PLANNING DEPARTMENT

PLANNED UNIT DEVELOPMENT APPLICATION (PUD 2004-000003)

Project Name:	Lehua Lani
Applicant & Consultant:	Riehm Owensby Planners Architects
Landowner:	Lehua Lani, LLC
Tax Map Key:	7-5-020: 071 & 72

Exhibit A: Master Plan

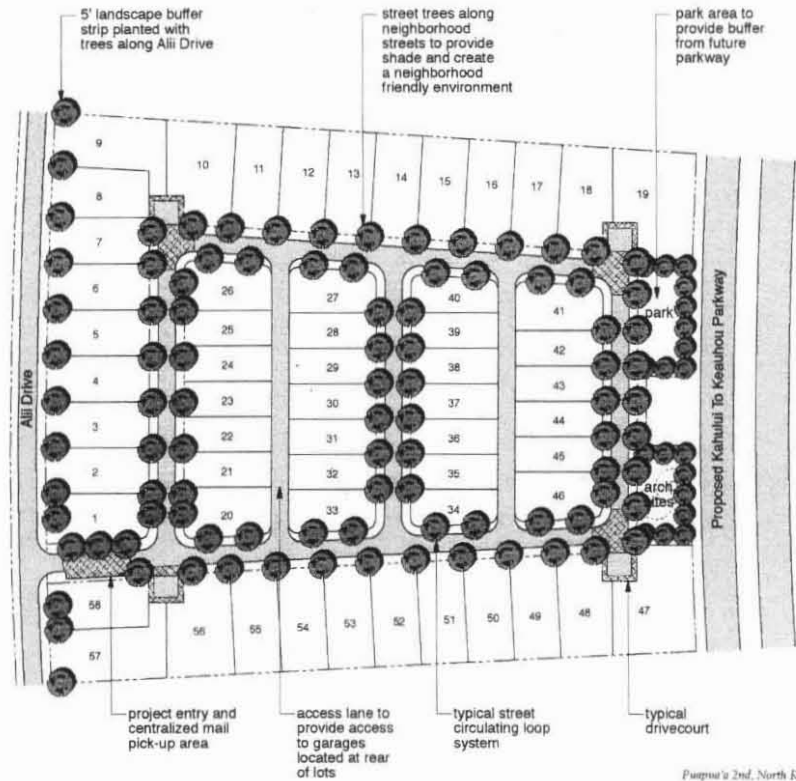
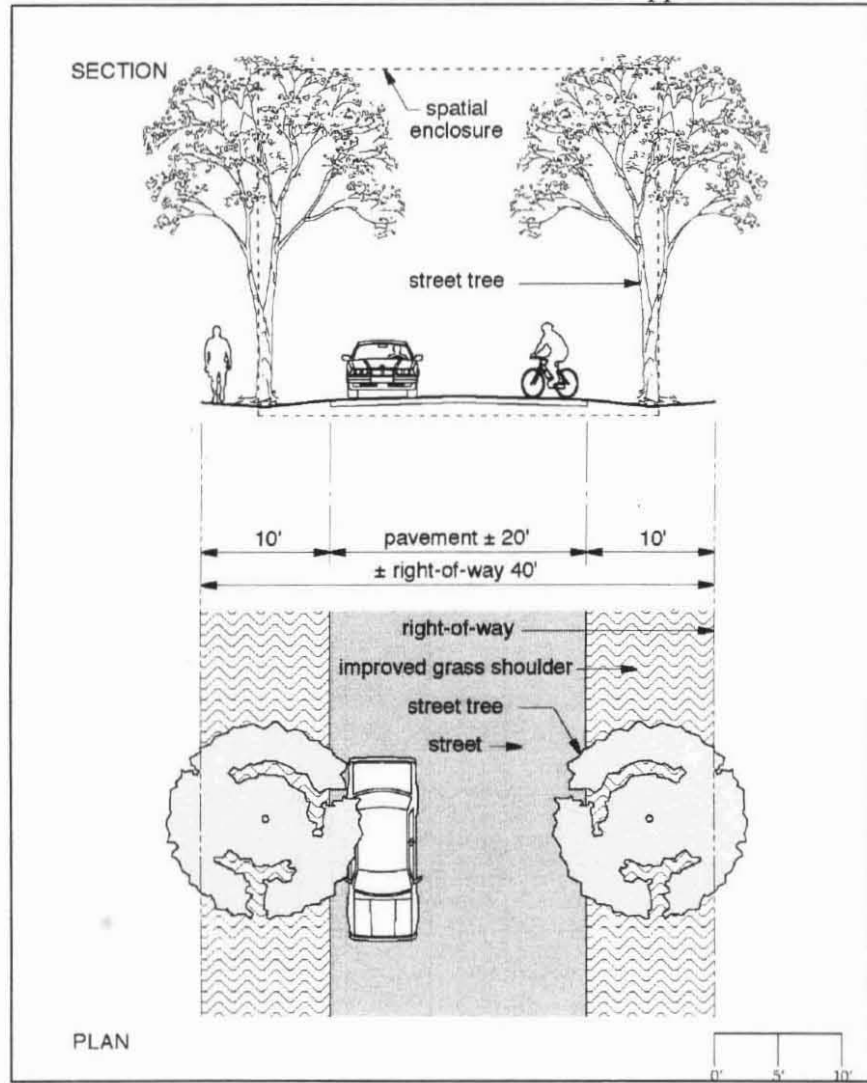
- C. Subdivision Approval. Subdivision approval shall be subject to the following conditions:
 1. Conformance with Master Plan. The final plat map shall show the lot layouts, building footprints, and setbacks as substantially represented in the master plan attached as Exhibit A, and include a certification by the applicant, surveyor, or architect on the final plat map of such conformance with this PUD.

- D. Building Permits Approval. Building permits shall be subject to the following conditions:
1. The siting of the residences and garages shall substantially conform to the master plan attached as Exhibit A.

Exhibit B: Approved Street Sections (Private, Non-Dedicable)

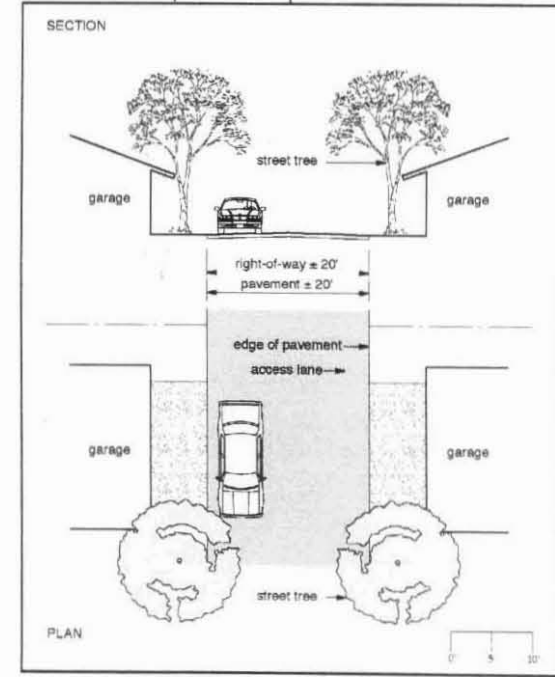
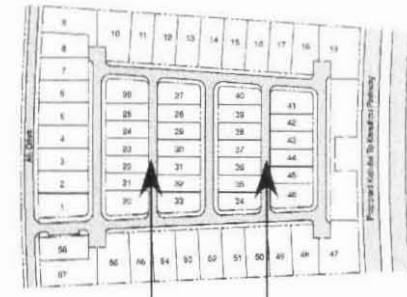
2. Minimum Right-of-Way and Pavement Widths (§23-41) (Variance Request #18). The Subdivision Code requires minor streets have a minimum right-of-way width of 50' with 20' pavement width (without curb/gutter/sidewalks) or 32' (with curb/gutter/sidewalk). The proposed street layout consists of minor roads. The design objective of the proposed street section is to reduce traffic speed and create a more intimate neighborhood through a narrower right-of-way with street trees, traffic calming islands, and special courtyard appearance at certain intersections. Acknowledging the relatively low traffic volume (not a subdivision with through roads) in this project and that the roads will remain privately owned and maintained, a variance is approved for a minimum 40' wide right-of-way with 20' pavement and 10' wide grass shoulders (no curbs, gutter, or sidewalk) for the main roads in accordance with Exhibit B. The alleys will be permitted to have a minimum 20' right-of-way with 20' pavement since its primary function is to provide a back-loaded entry onto the lots and not as the primary access road or pedestrian way. Because of the relatively low traffic volume and reduced speed, pedestrians will share the roadway with the vehicles. These streets shall be private nondedicable streets.

6. Right-of-Way Improvement (§23-95) (Variance Request #30). The Subdivision Code requires the entire right-of-way to be improved. This variance allows the right-of-ways to be developed as shown on Exhibit B.

4. Non-Dedicable Private Streets. The approved street sections (Exhibit B) shall be private, non-dedicable streets. The preliminary plat or final subdivision approval submittal shall include a

Exhibit C: Approved Yard Setbacks

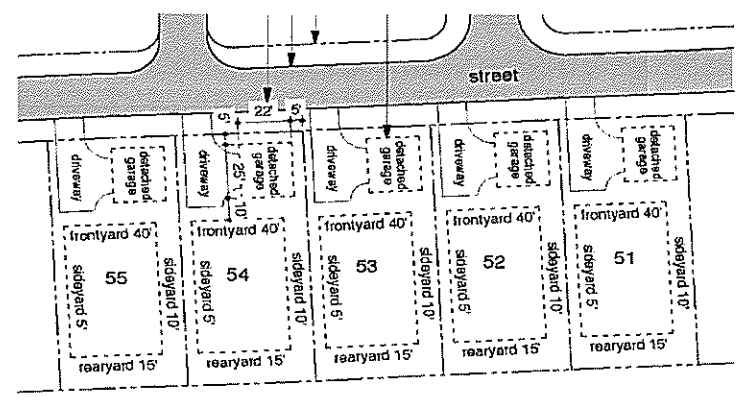
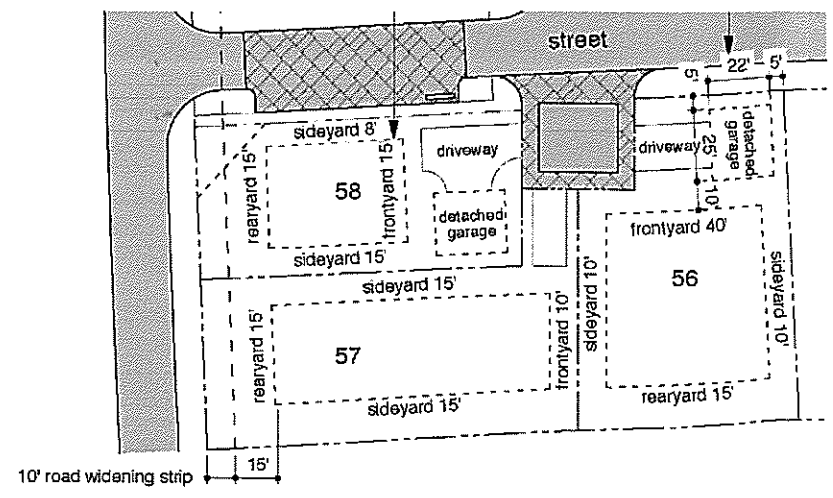
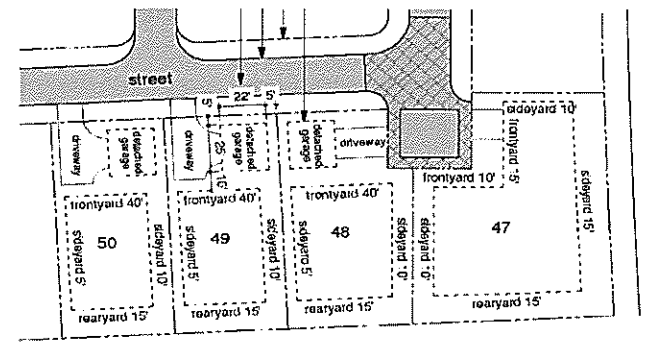
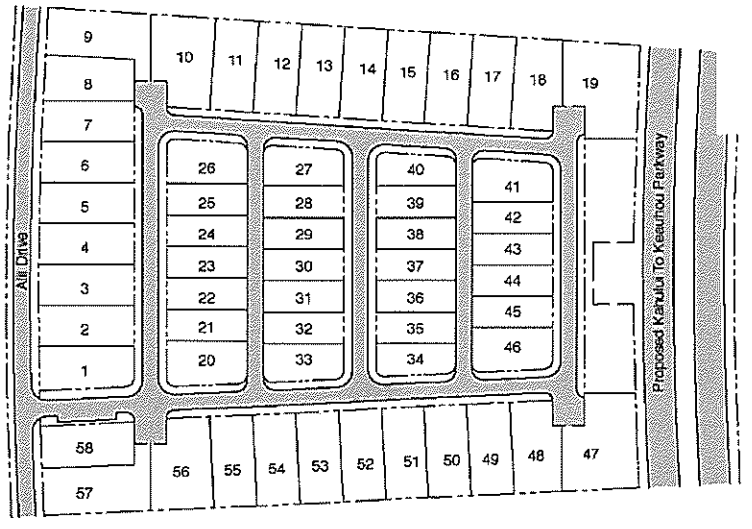
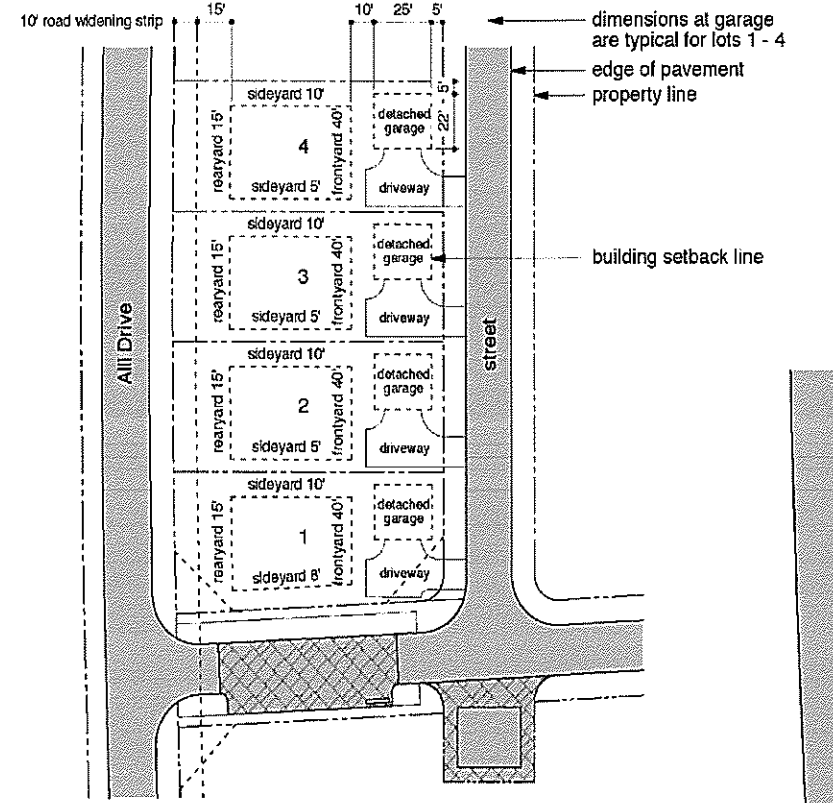
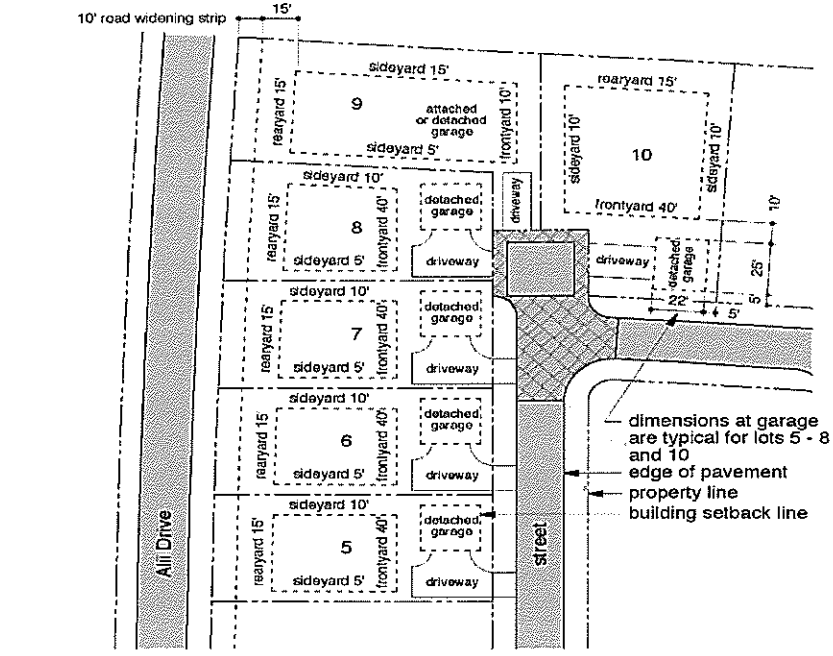
2. Yard Requirements §25-5-7 (Minimum Yards-RS), §25-4-40 (permitted projections into yards and open spaces), §25-4-42 (corner building sites) (Variance Requests #10, 5, 7). The minimum yards in the RS-7.5 district are: 15' from the front and rear property boundaries and 8' from the side property boundaries. The master plan offsets the footprint of the homes to one side of the lot so that the distance between the homes is substantially equivalent (no less than 15 feet) to the 16' feet that would result from the code requirements. The main house structure will maintain a minimum 15' setback from the front and rear property boundaries, as required by the zoning code. However, the detached garage structure will be situated at least 7' from its front property line, providing a clearspace from its roof eaves of 4'. The garages are oriented with the side facing the street. There will be an adequate driveway apron fronting the entry to the garage to provide for onsite parking outside the garage without the parked cars encroaching into the right-of-way. The other site plan is for the garage to be located at the rear of the lot and accessed by a lane. The approved yards shall be as shown on the attached Exhibit C.
